AEP-NRC-2014-24  
10 CFR 50.90

Donald C. Cook Nuclear Plant Units 1 and 2  
License Amendment Request Regarding a Change to the Reactor Coolant System Pressure and Temperature Limits

### **Safety Evaluation of Proposed Changes to Unit 1 and Unit 2 Technical Specification 3.4.3**

Figure 3.4.3-1 (page 1 of 1)  
Reactor Coolant System Pressure versus Temperature Limits -  
Heatup Limit, Criticality Limit, and Leak Test Limit  
(Applicable for service period up to 32 EFPY)

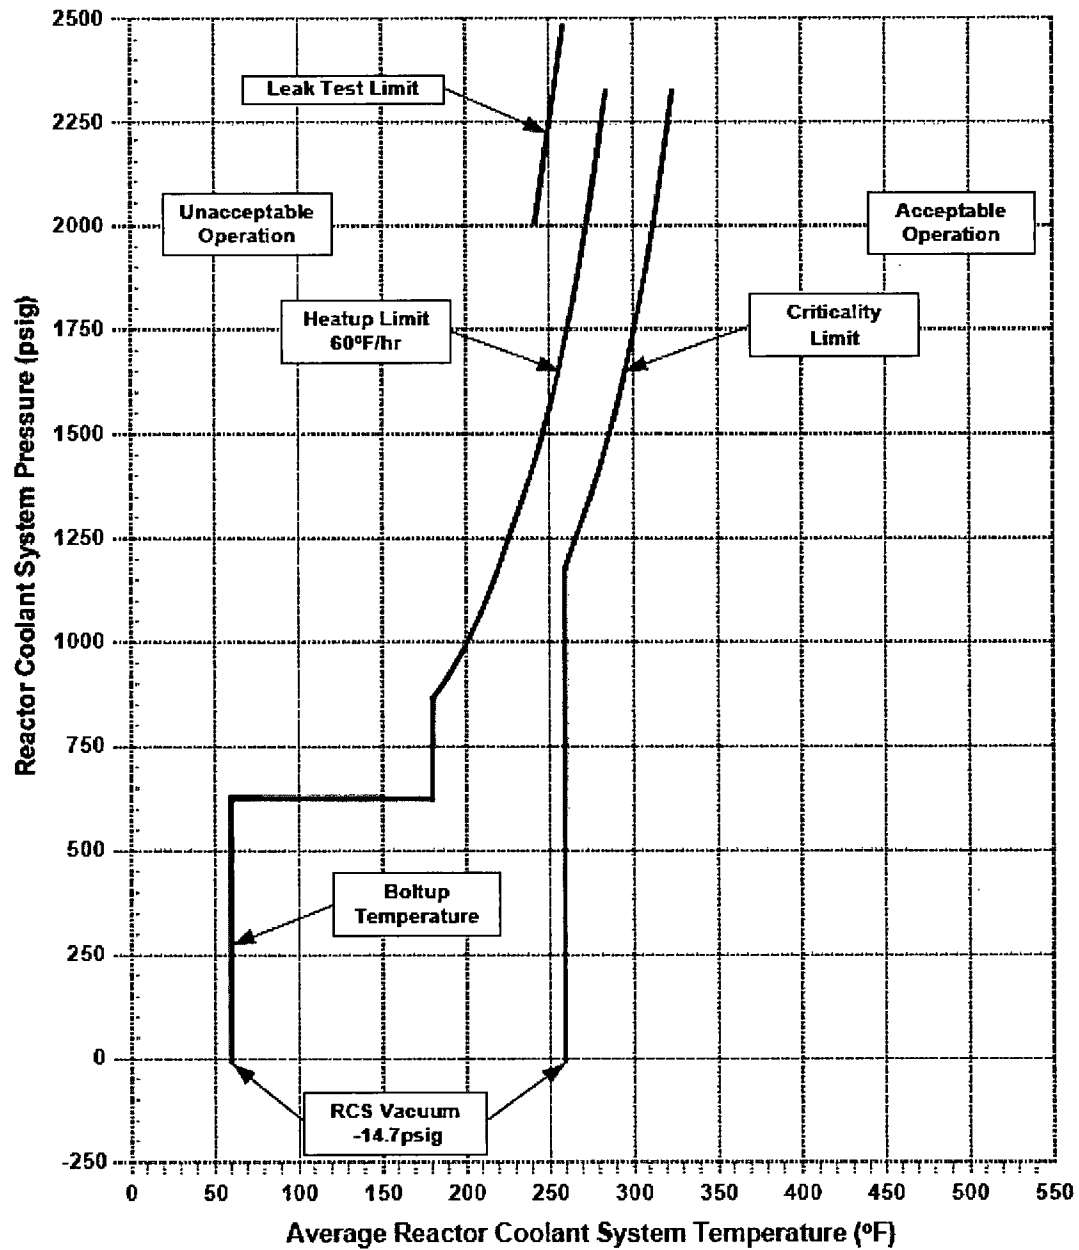
The proposed amendment would revise the CNP Unit 1 and Unit 2 TS 3.4.3, changing Figures 3.4.3-1 "Reactor Coolant System Pressure versus Temperature Limits – Heatup Limit, Criticality Limit, and Leak Test Limit (Applicable for service period up to 32 EFPY)" and 3.4.3-2 "Reactor Coolant System Pressure versus Temperature Limits – Various Cooldown Rates Limits (Applicable for service period up to 32 EFPY)". The proposed changes to these figures would include extending the y-axis (ordinate) below 0 pounds per square inch gauge (psig), as well as extending the curves to -14.7 psig. These changes provide the graphical representation of vacuum conditions, which would be encountered during vacuum fill evolutions

Since the pressure axis for these curves terminates at 0 psig, operation of the RCS in a pressure condition less than 0 psig (e.g. RCS vacuum fill conditions) is not enveloped per the current TS defined P/T conditions.

and during vacuum fill

Figure 3.4.3-2 (page 1 of 1)  
Reactor Coolant System Pressure versus Temperature Limits -  
Various Cooldown Rates Limits  
(Applicable for service period up to 32 EFPY)

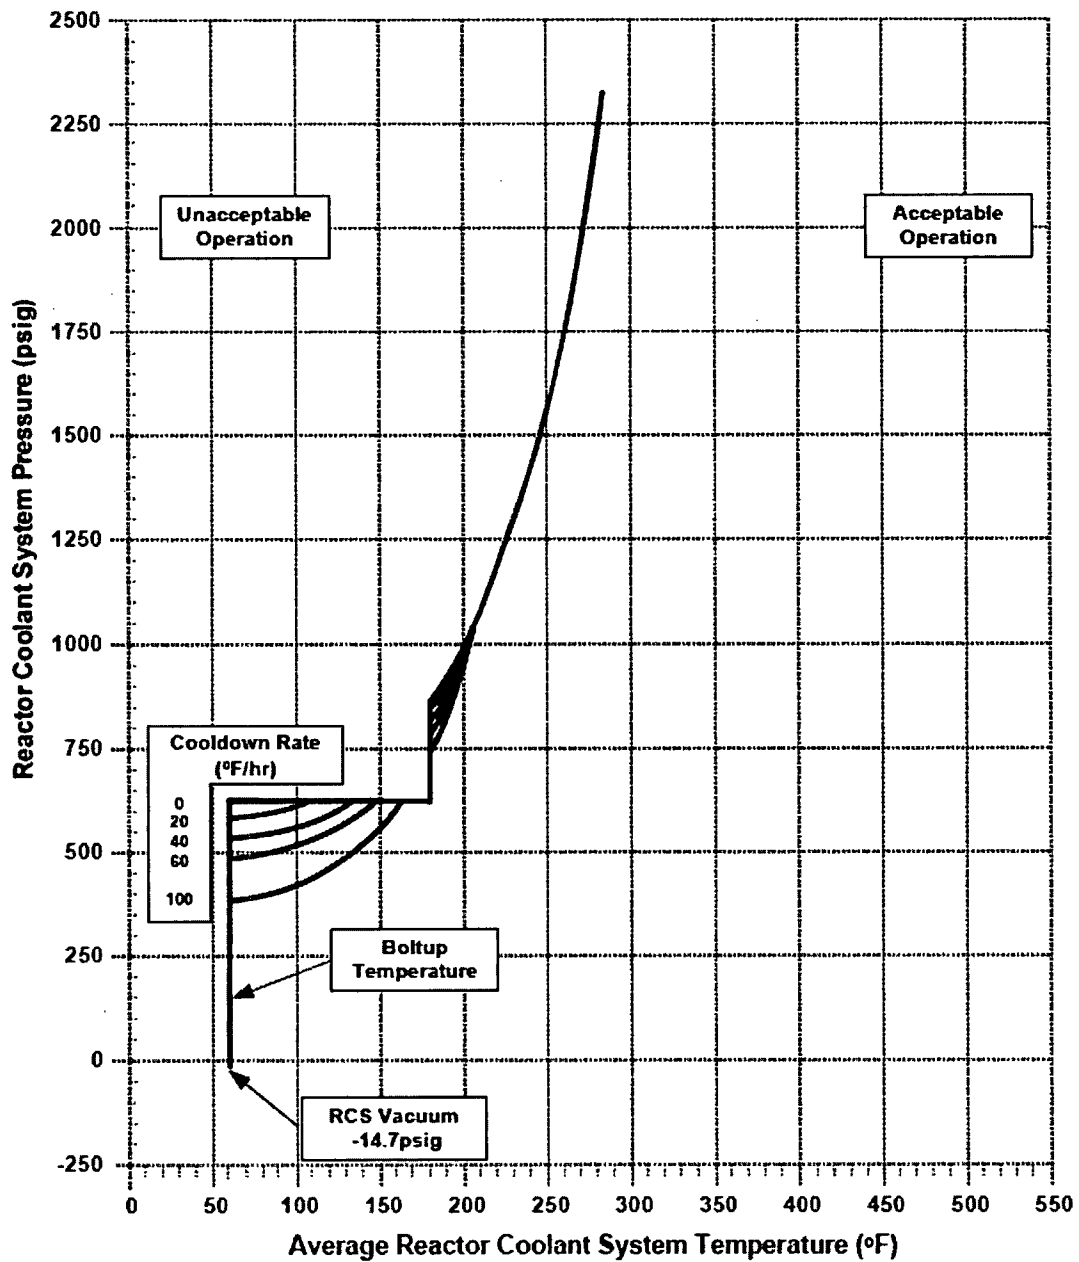
and during vacuum fill

Figure 3.4.3-1 (page 1 of 1)  
Reactor Coolant System Pressure versus Temperature Limits -  
Heatup Limit, Criticality Limit, and Leak Test Limit  
(Applicable for service period up to 32 EFPY)

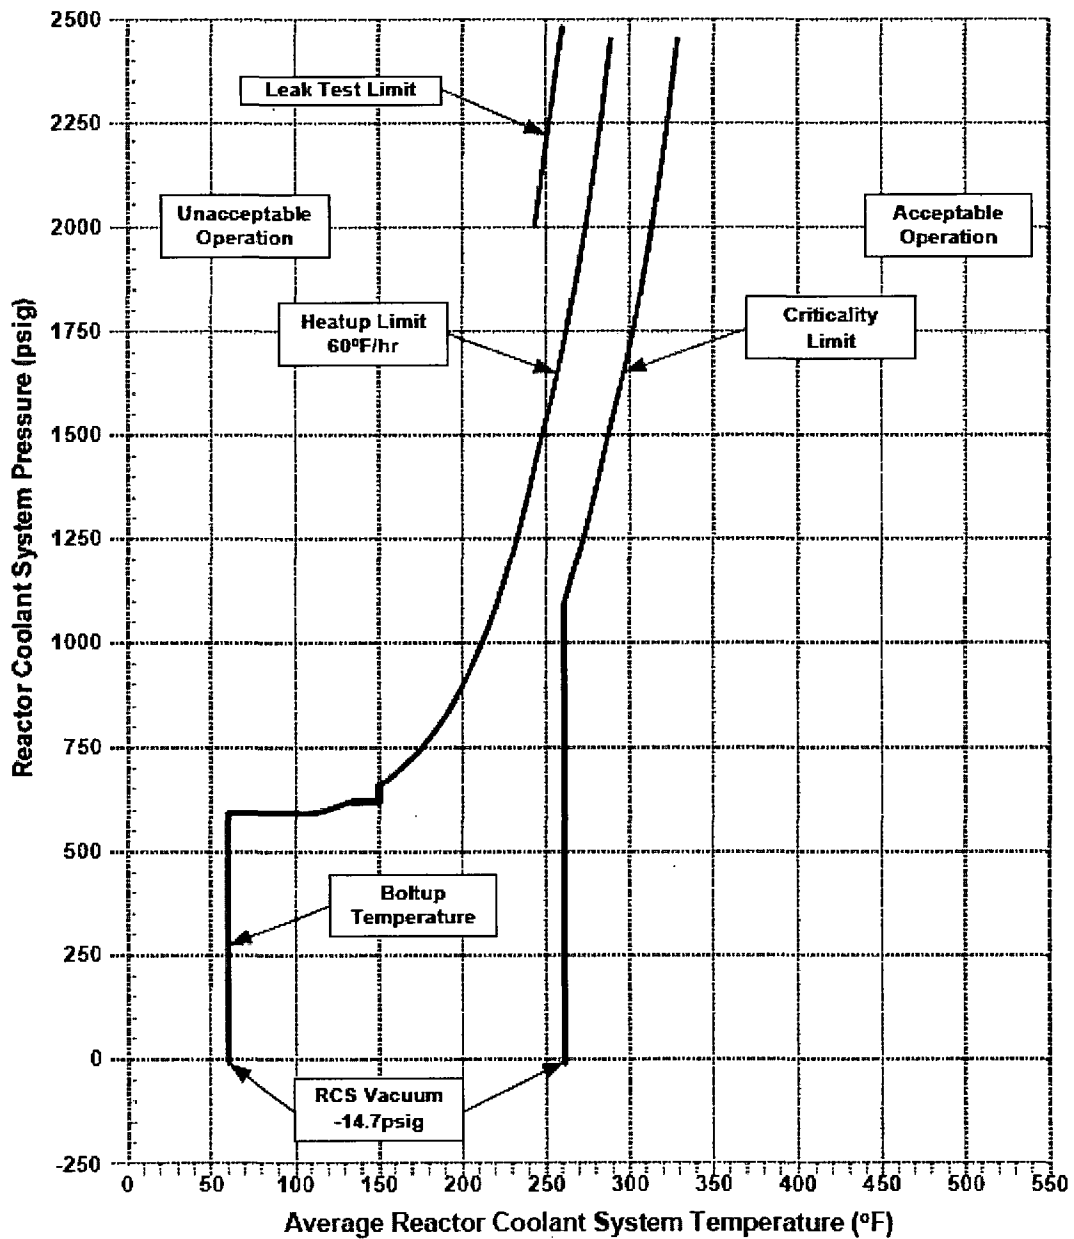
and during vacuum fill

Figure 3.4.3-2 (page 1 of 1)  
Reactor Coolant System Pressure versus Temperature Limits -  
Various Cooldown Rates Limits  
(Applicable for service period up to 32 EFPY)

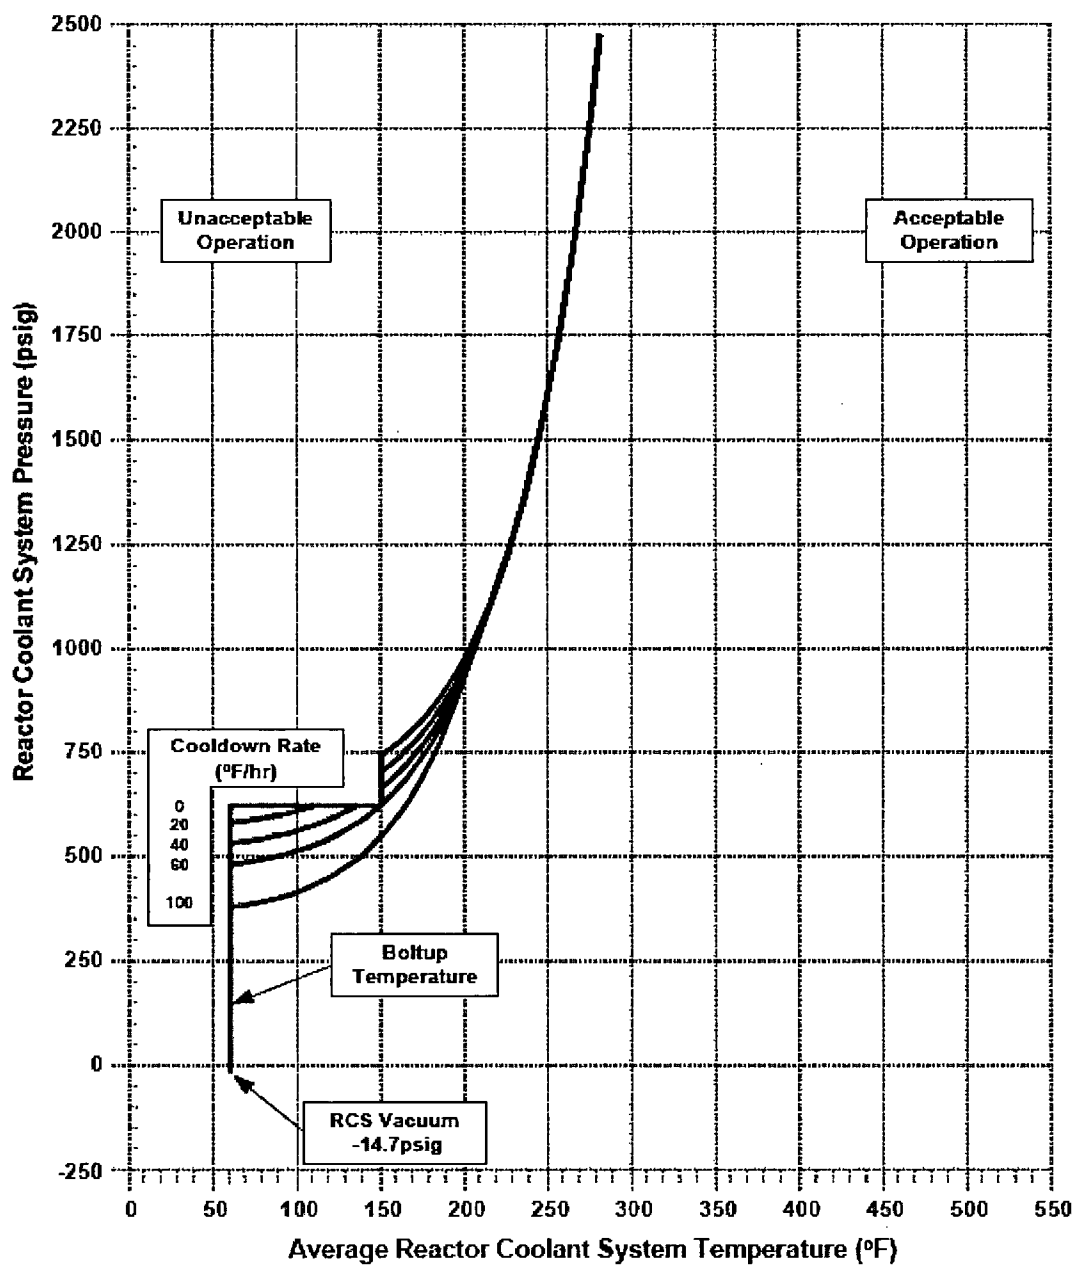
and during vacuum fill
